PROJECT NAME: MARBACH ROAD PH IIB
CIMS PROJECT NO. 40-00308

ADDENDUM NO. 1

Addendum No. 1 is issued to notify, add, change and replace the following:

MAP No. _____ SHEET 5 OF 12
 SECT. No. _____
 DR. MC CK. LDLT JOB No. 12-5021

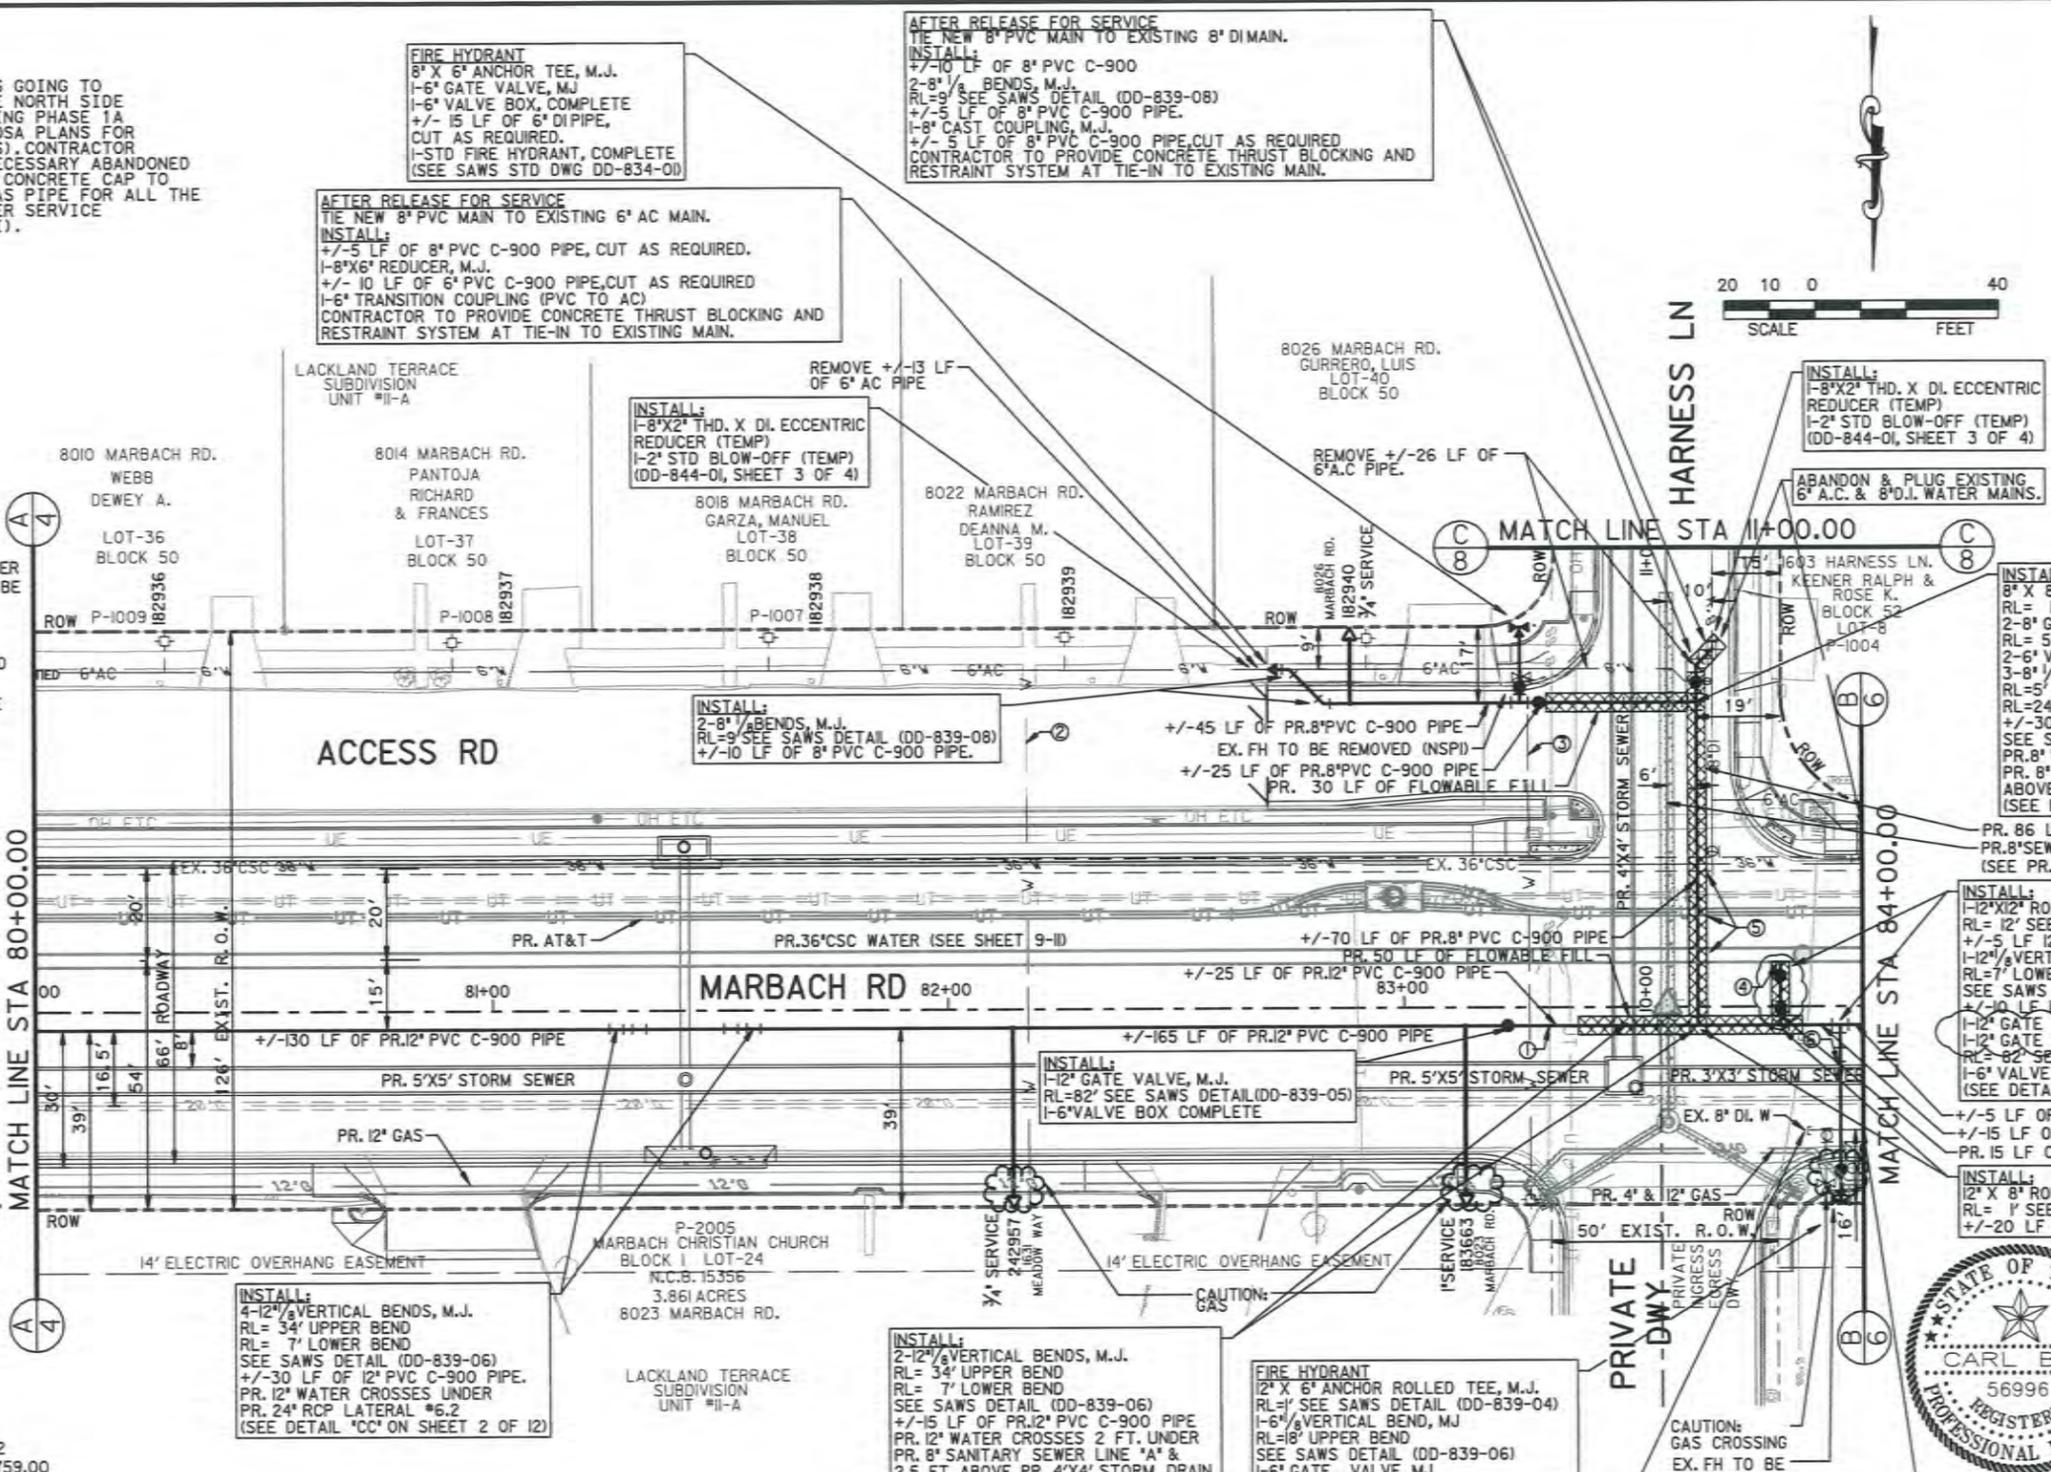
- 8) SAWS WATER PLANS: A 12” gate valve has been added to the plans. Replace the following Plan Sheets:
 - a. Sheet 2, Water General Notes & Quantities
 - b. Sheet 5, Water Plans

REV. NO.	DATE	DESCRIPTION	BY
1	12-06-13	ADDENDUM I - REVISED PER SAWS COMMENTS	BMB

INSTALL:
 1-12" GATE VALVE, M.J.
 RL=82 SEE SAWS DETAIL (DD-839-05)
 1-6" VALVE BOX COMPLETE
